Access Compliance Report

Public Rights-of-Way

(Curb Ramps)

Intersection ID: 5468	Main Street: N_TRYON_ST	Cross Street: J_W_CLAY_BV	Location: N
ADA ID: B28980D093CE	Ramp Type: Perp	Initial Pass/Fail: Fail	Overall Compliance: No
Severity Score: 21.25			
Codes/Mitigation Info/Possible Solution		Field Measurements/Component Compliance

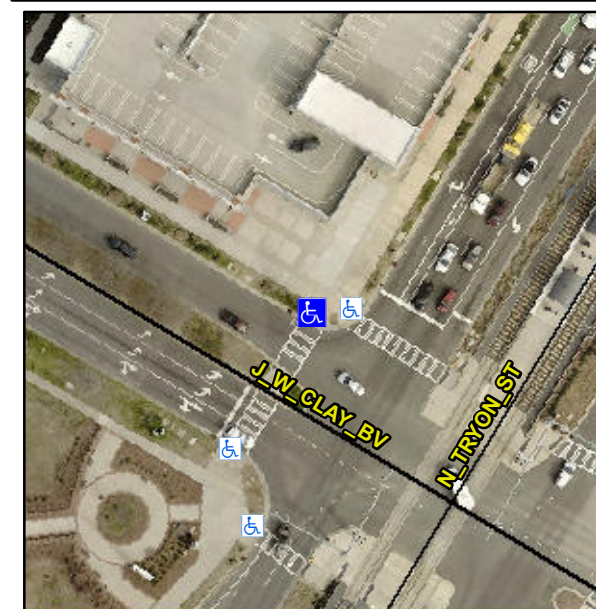
R304.5.1, R304.2.2

Compliance	Description	Data	Compliance	Description	Data
N/A	Ramp Length (in)	72.0	No	Ramp Slope (%)	8.9
No	Ramp Width (in)	47.0	Yes	Ramp XSlope (%)	1.1
N/A	Flare Type LT	N/A	N/A	Flare Type RT	N/A
N/A	Flare Slope LT (%)	N/A	N/A	Flare Slope RT (%)	N/A
N/A	Flare Traversable LT?	N/A	N/A	Flare Traversable RT?	N/A
N/A	Landing Length (in)	N/A	N/A	DWS Provided?	N/A
N/A	Landing Width (in)	N/A	N/A	DWS Contrast?	N/A
N/A	Landing Slope (%)	N/A	N/A	DWS Length (in)	N/A
N/A	Landing X Slope (%)	N/A	N/A	DWS Full Width?	N/A
N/A	Landing Curb? (Y/N)	N/A	N/A	DWS Offset (in)	N/A
N/A	Shared Landing?	N/A			
N/A	Gutter Ponding?	N/A	N/A	Gutter Slope (%)	N/A
N/A	Gutter Lip Ht (in)	1.5	N/A	Gutter X Slope (%)	N/A
N/A	Painted X Walk1?	No	N/A	Painted X Walk2?	N/A
	X Walk 1 Direction	To SW		X Walk 2 Direction	N/A
N/A	X Walk 1 Width (in)	N/A	N/A	X Walk 2 Width (in)	N/A
	X Walk 1 Slope (%)	2.2		X Walk 2 Slope (%)	N/A
	X Walk 1 X Slope (%)	0.4		X Walk 2 X Slope (%)	N/A

Remove & Replace Entire Ramp.
